AD-8000 Power Supply Unit

After over 6 years of servicing the AD-8000, the Apogee Service Department has acquired significant insight into troubleshooting the AD-8000 Power Supply Unit. In order to expedite repairs in the field, we offer the following guidelines, including schematics and board layout documents.

Updating to Revision E4

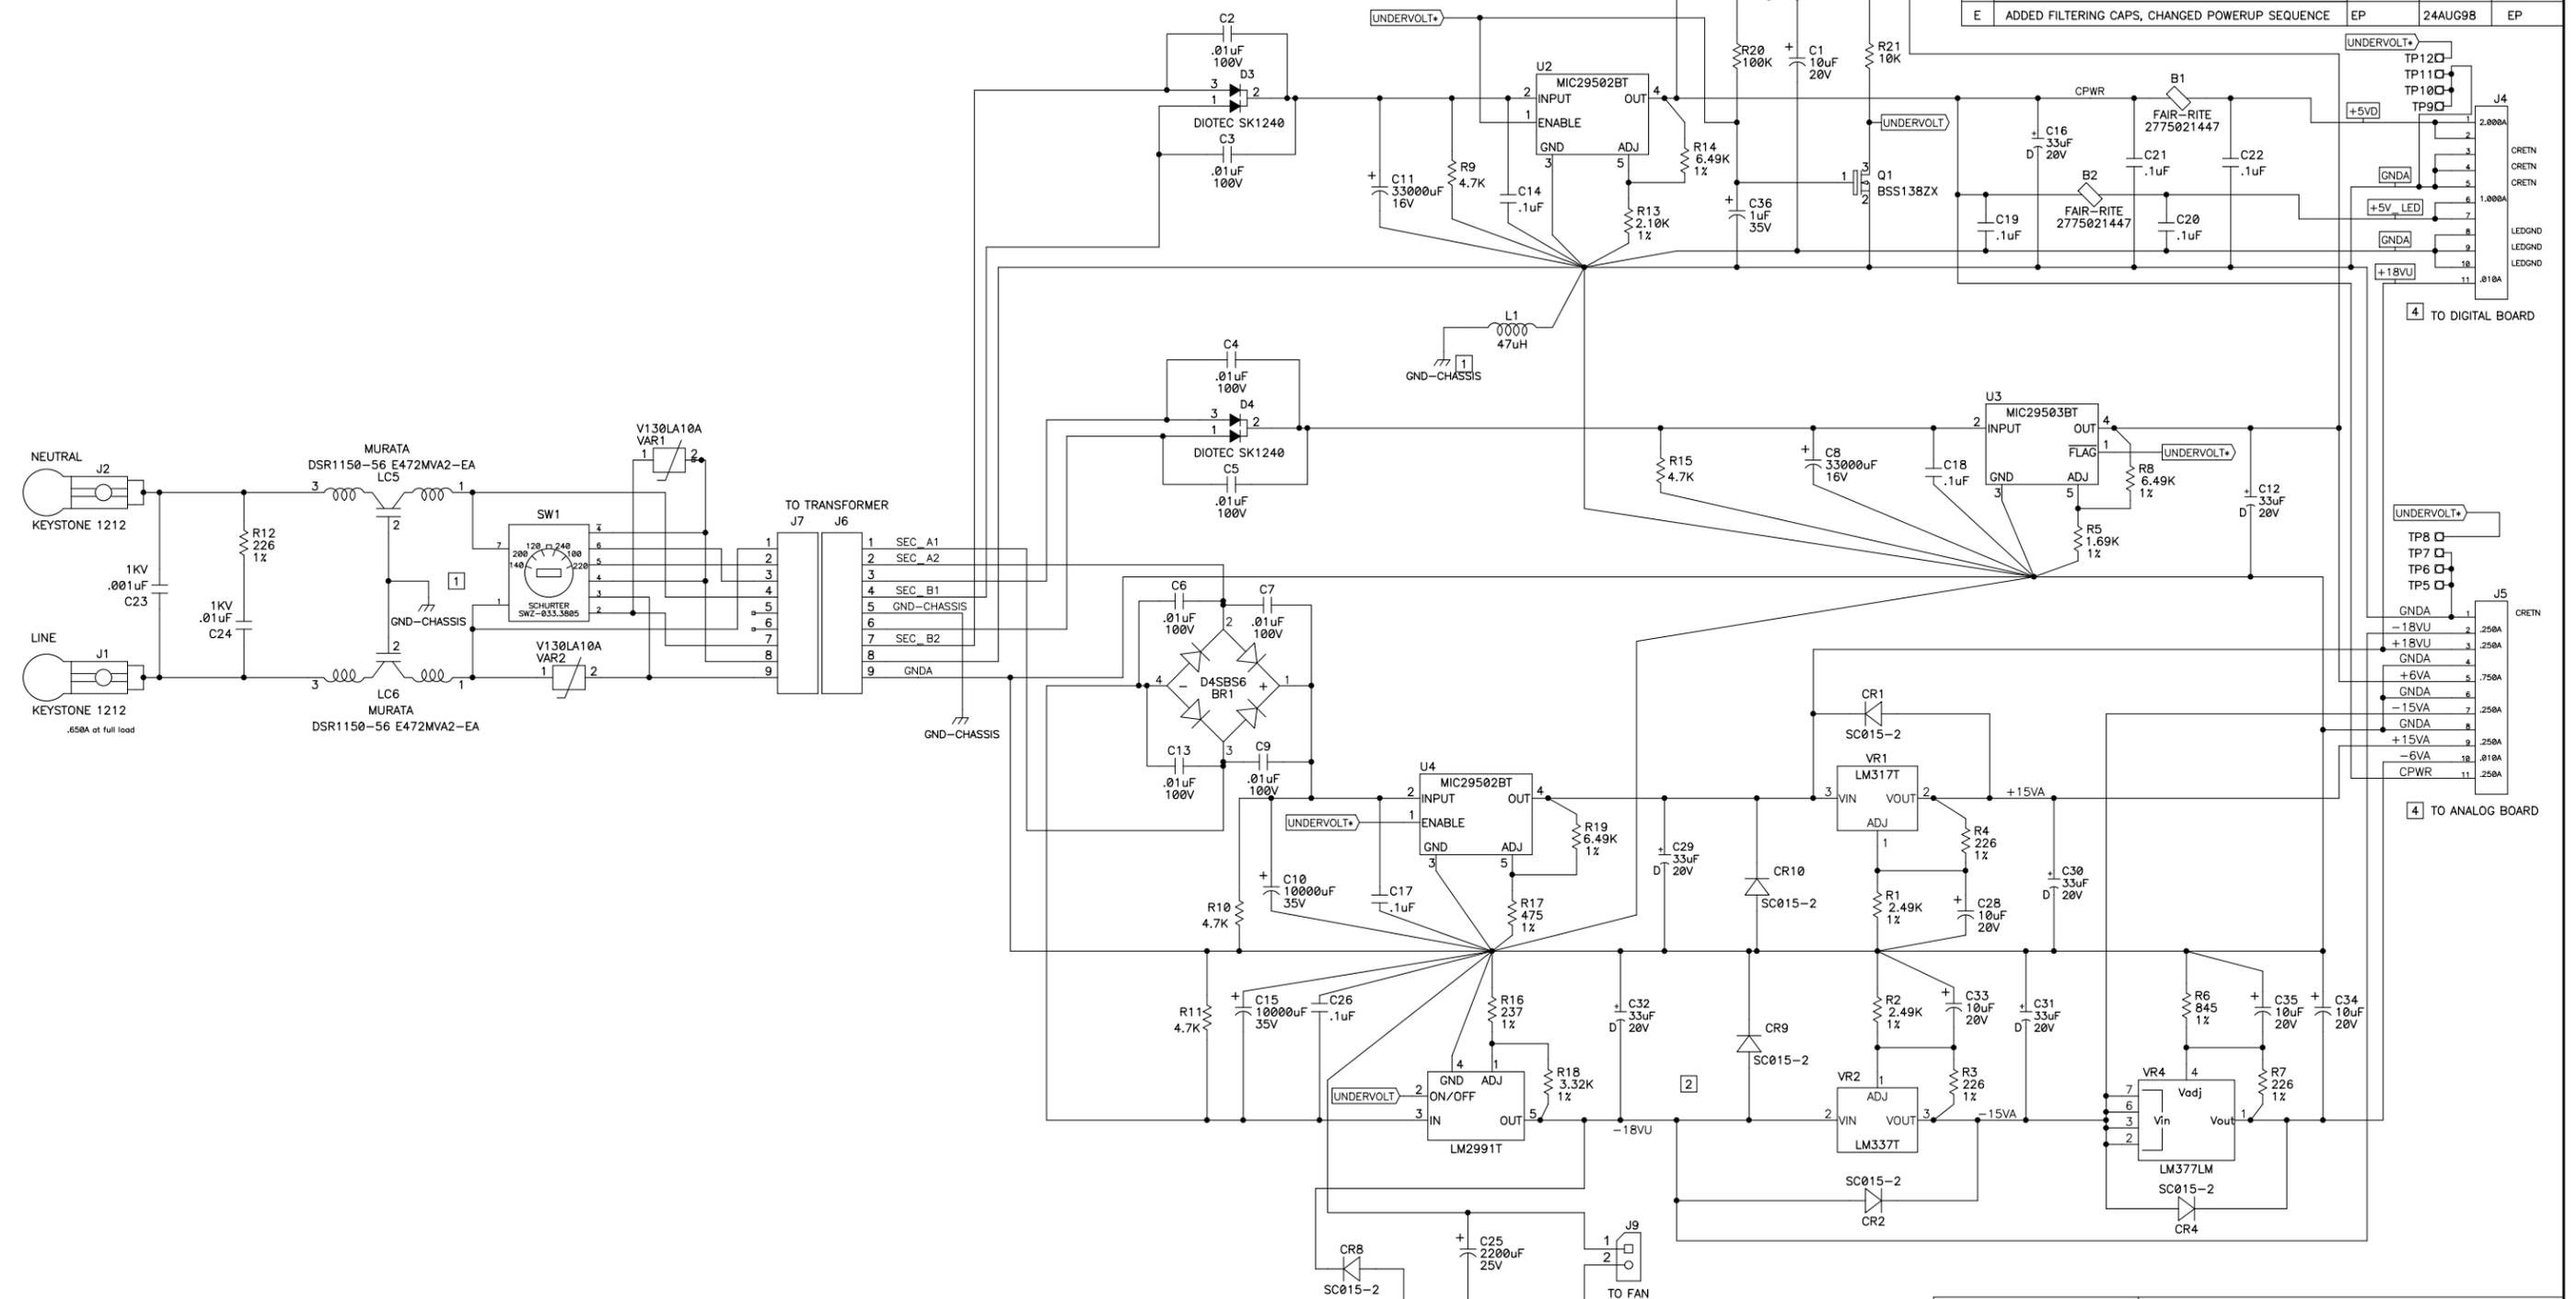
All AD-8000 PSUs should be updated to revision E4; this may be accomplished by performing the following modifications. See the schematic and board layout diagrams at the end of this document to locate the components to be changed.

- 1) Change R14 to 6.81kOhms 1/4watt 1% resistor
- 2) Change R8 to 6.04kOhms 1/4watt 1% resistor
- 3) Change R6 to 768 Ohms 1/4watt 1% resistor
